Project Number:
1006864

The applicant requests for an exception to the maximum allowed heights in the Northwest Mesa Escarpment Plan (NWMEP) for seven lots located on Tract M of the Watershed subdivision,

FINDINGS – 17 EPC-40004 April 13, 2017 Site Development Plan for Subdivision

SECTION F-F
SCALE 1"=100'

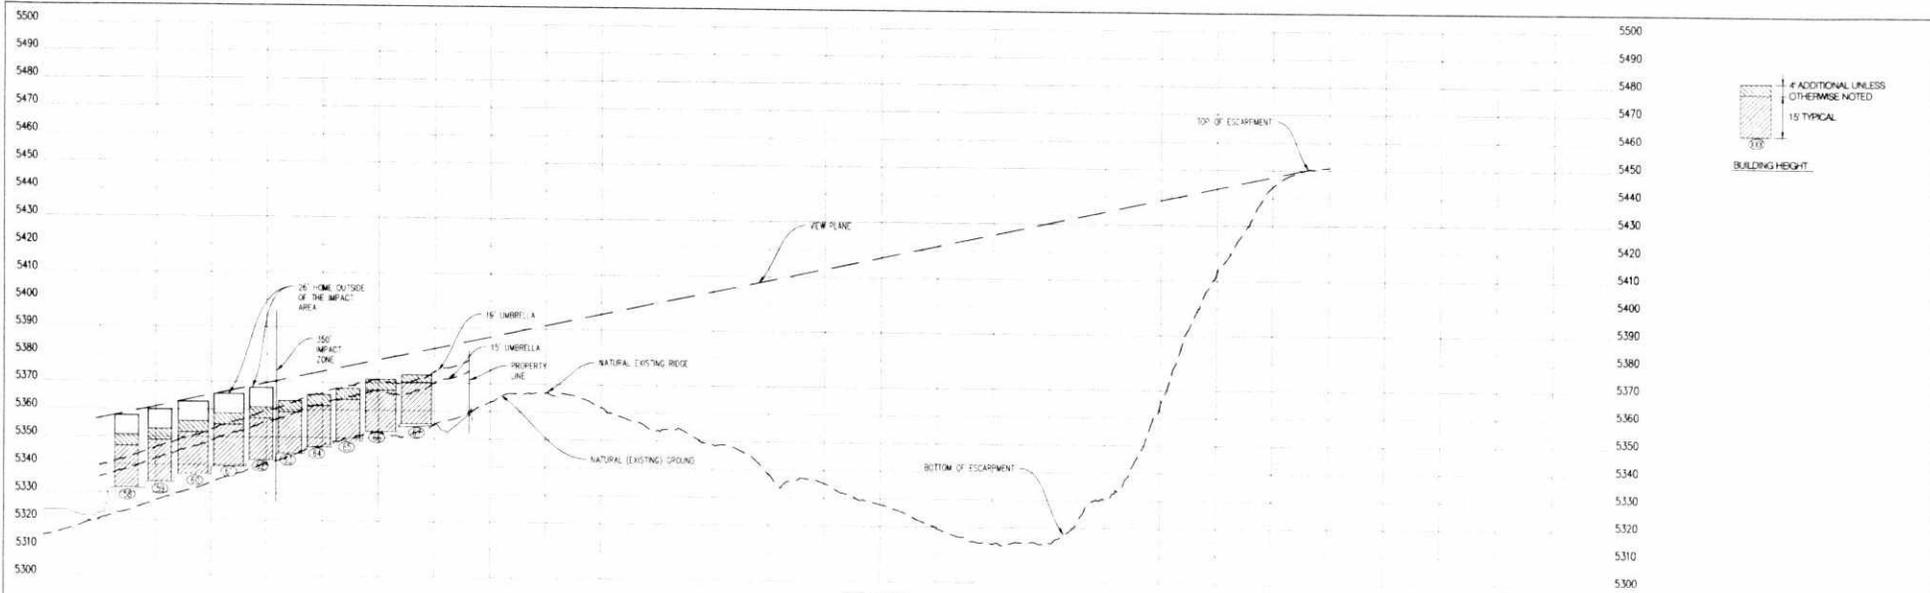
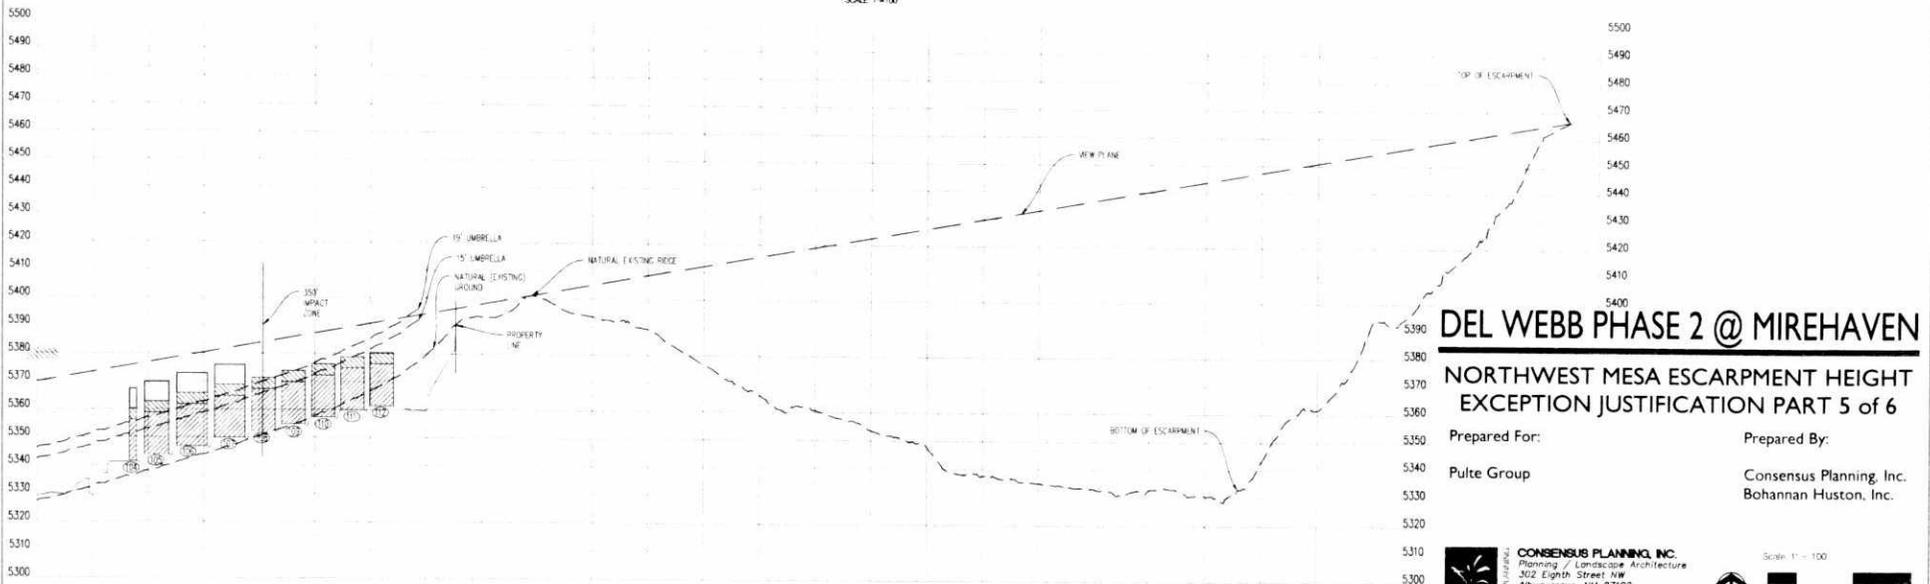
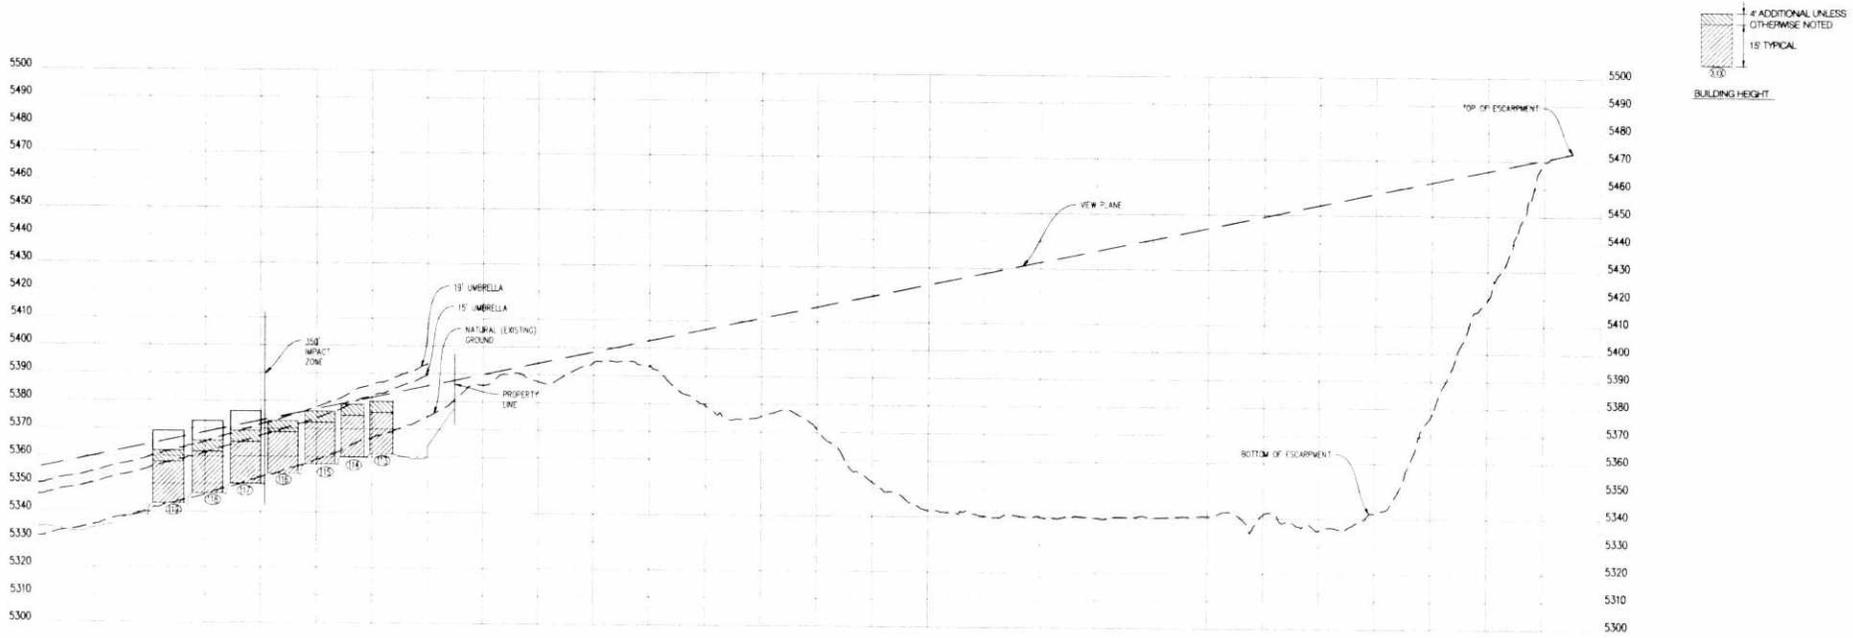
The chart on sheet 4 of 6 of the SPS, Exception Justification, shows that the additional height on lots 66 and 67 will have more of an impact on the views than the additional height on other lots because of the proximity to the monument and because the escarpment and the ridge slope is lower at this point in the development.

The request is generally consistent with intent of the NWMEP to protect views to the escarpment face and to protect the edge of the Petroglyph National Monument. The applicant submitted view analysis diagrams to show that the impact of the additional height on views to the escarpment will not be significant, except for lots 66 and 67 where staff recommends that heights be limited to less than 17 feet to protect the views.

The application includes a Grading and Drainage Plan that has been approved by the City Engineer as required by the exception process in the Northwest Mesa Escarpment Plan. The applicant submitted view analysis diagrams to show that the impact of the additional height on views to the escarpment will not be significant, except for lots 66 and 67 where staff recommends that heights be limited to protect the views.

1. The EPC delegates final sign-off authority of this site development plan to the Development Review Board (DRB). The DRB is responsible for ensuring that all EPC Conditions have been satisfied and that other applicable City requirements have been met. A letter shall accompany the submittal, specifying all modifications that have been made to the site plan since the EPC hearing, including how the site plan has been modified to meet each of the EPC conditions. Unauthorized changes to this site plan, including before or after DRB final sign-off, may result in forfeiture of approvals.
2. Prior to application submittal to the DRB, the applicant shall meet with the staff planner to ensure that all conditions of approval are met.
3. Height on lots 66 and 67 shall be limited to less than 17 feet from finished grade.
4. Conditions of Approval from other agencies...
